LICENSE INSPECTOR REPORT

TRADE NAME: Mexico y Mexico Coffee Shop Inc.
DBA: Mexico y Mexico

LICENSE APPLIED FOR: Sidewalk Cafe

Mexico Y Mexico
1831 Central Avenue
612-781-0200
Outdoor Seating Plan

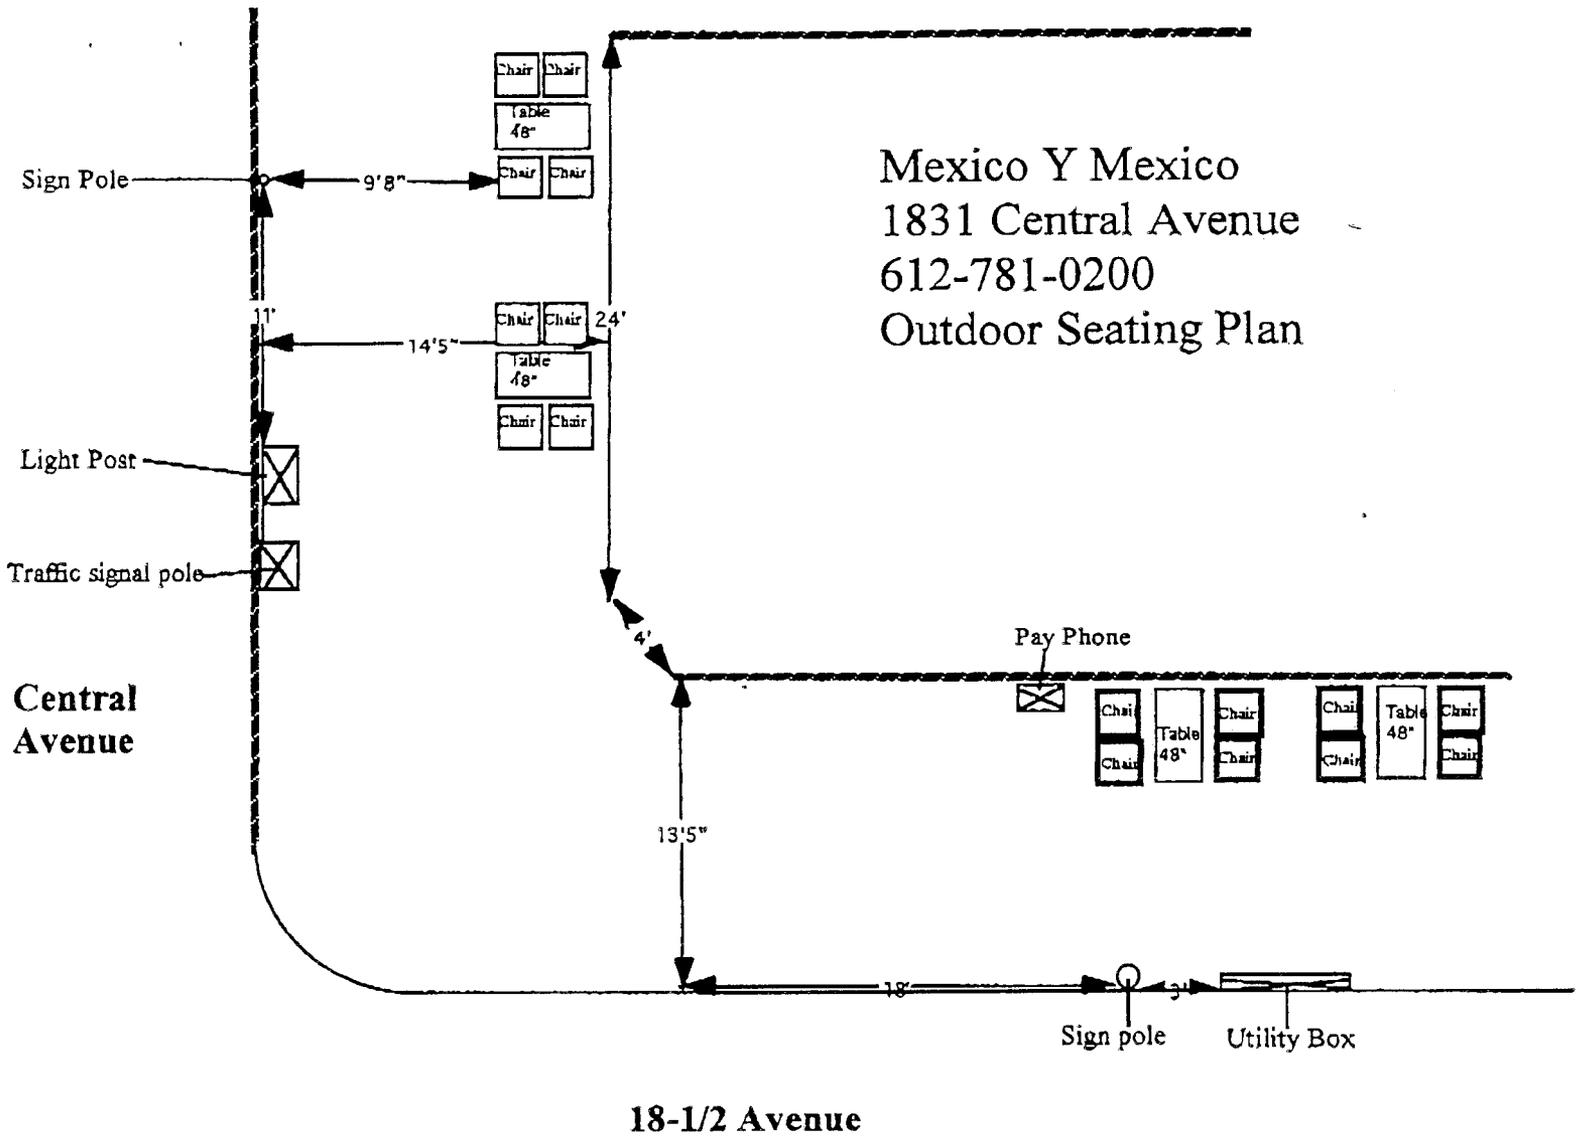
Transportation Engineer Doug Maday has reviewed the application and has indicated a four and one half (4 ½) foot clear walkway will be preserved on Central Ave NE and a four-foot walkway on Eighteenth and one half (18 ½) Ave NE if the area is operated in accordance with the plan that was submitted. In addition, the designated sidewalk café area on Central Ave NE must start 12 feet north of building corner.

9.) Additional comments:
6' Cafe Approved on 18 1/2 Street NE leaving 4' ft. walkway.
6' Cafe approved on Central starting 12' north of building corner. leaving 4 1/2' walkway
